# GARRISON LAW CORPORATION

Re: Request for Review and Approval of Proposed Workplan

**DRAFT  
SITE ASSESSMENT WORK PLAN**

**Schropp Farms – East Property  
3880 Mountain House Road  
Byron, California**

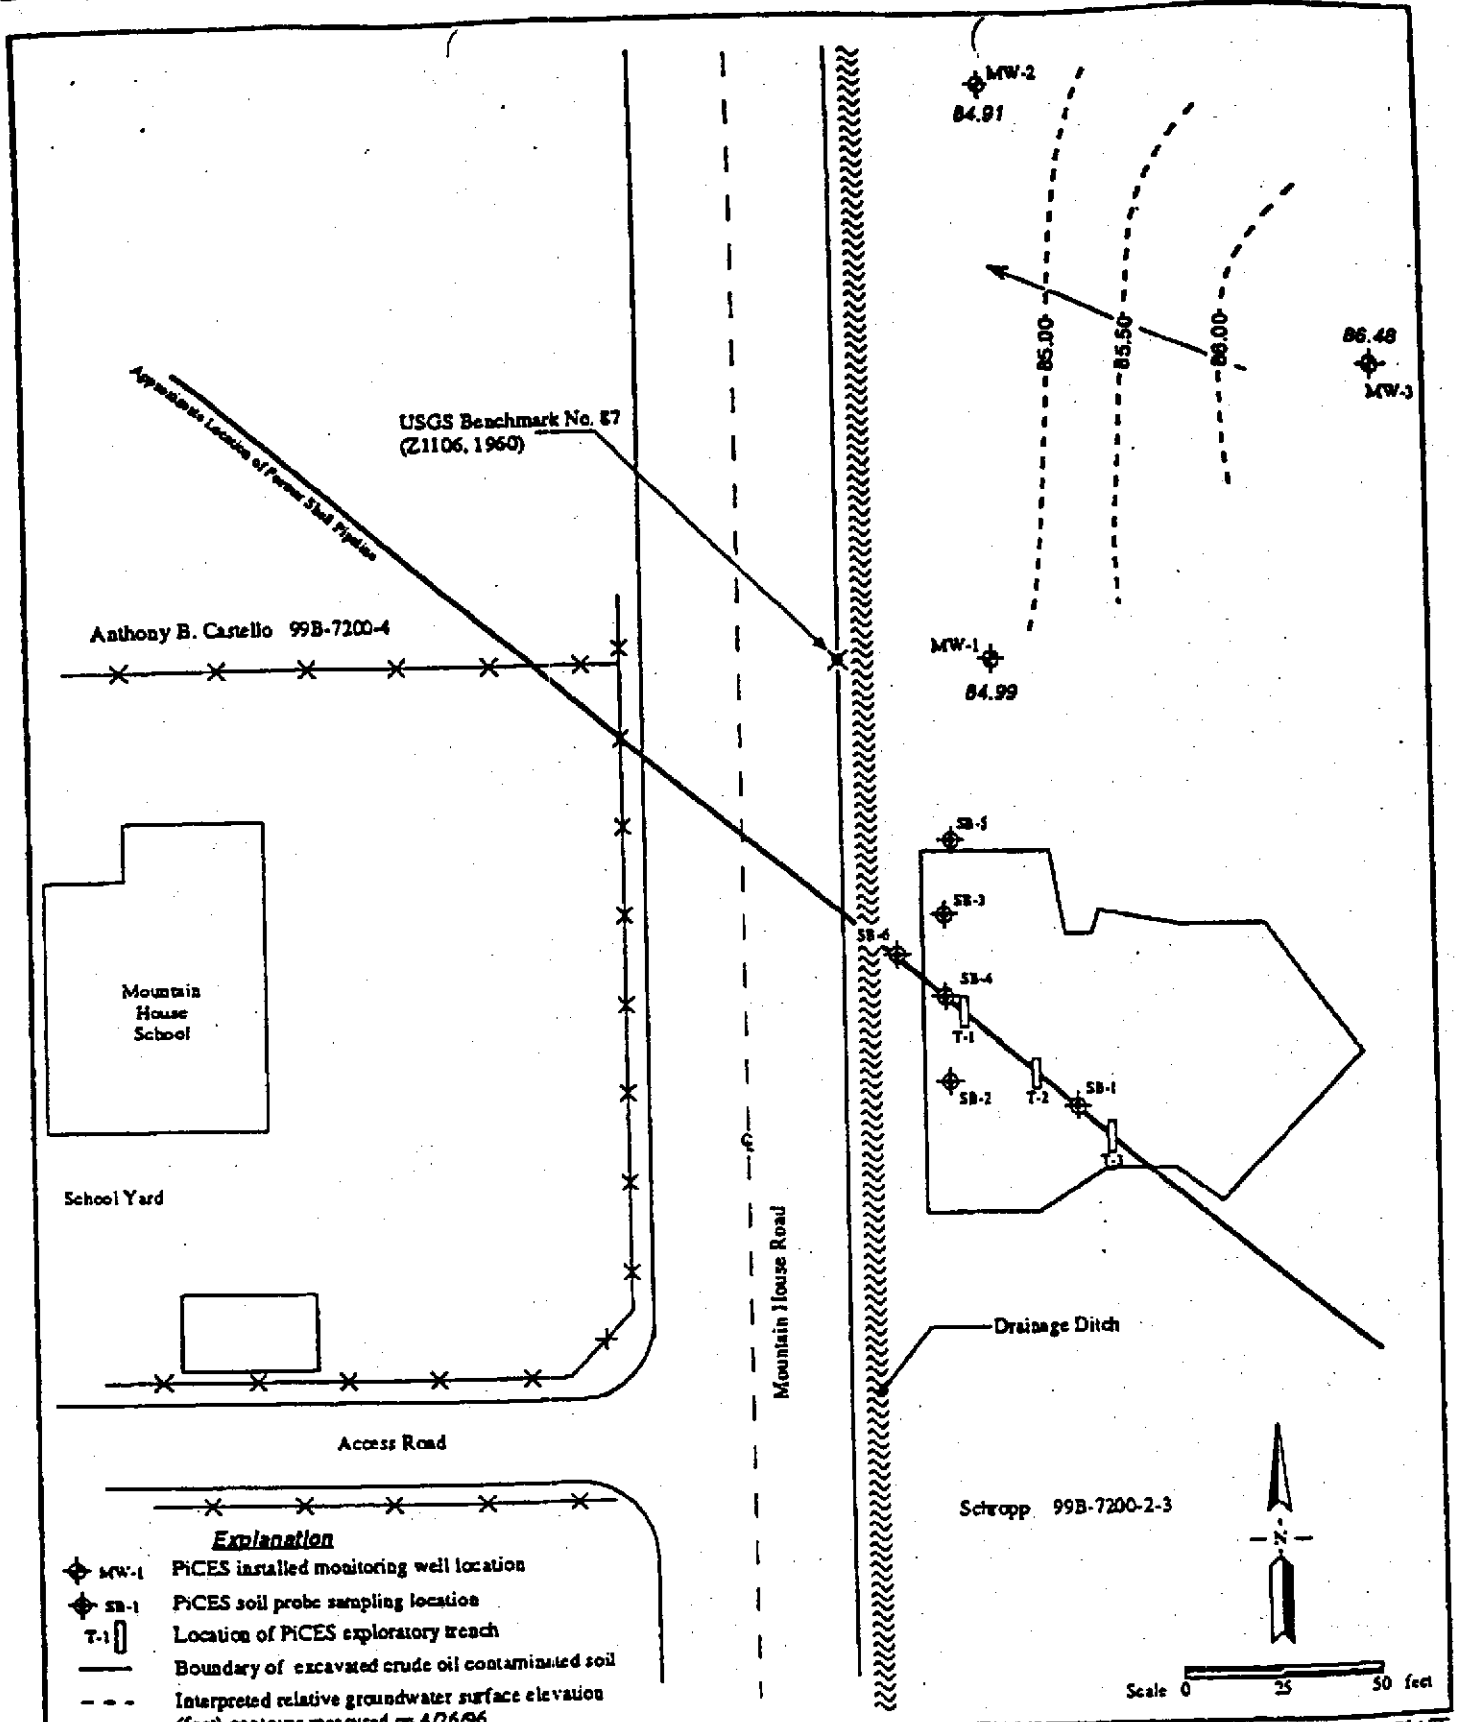
The July 1997 Geoprobe borings should have included a sample near the plume center and a sample from greater depth, such as 25 feet bgs, to help characterize the extent of contamination. The levels of TPHc in the groundwater were high, 1,600 ug/l at B-3, which points to a need to define the full extent of TPH constituents in the groundwater.

Ambient conditions are not equally comparable when assessing underground conditions for crude oil, specifically when a leaky pipeline allowed flow into subsurface sediments. The 30 years of deposit time, perhaps longer at this site during the pipelines' operation, allows for a much greater extent of contamination, especially in the downgradient direction towards the west. This possibility is supported by the evidence of soil contamination at the deepest point exhibited along the western side of the excavation. The lack of clear evidence that the contaminant source has been fully removed points to the need for further delineation of the soil contamination.

Soil and groundwater samples from adequate depths, such as 15 and 25 feet bgs, need to be taken across Mountain House Road in the downgradient direction near the old pipeline. The closure of the well used by the Mountain House school across the road to the west, raises the question as to the extent of affected groundwater. Therefore, further information is needed before a NFA letter can be issued.
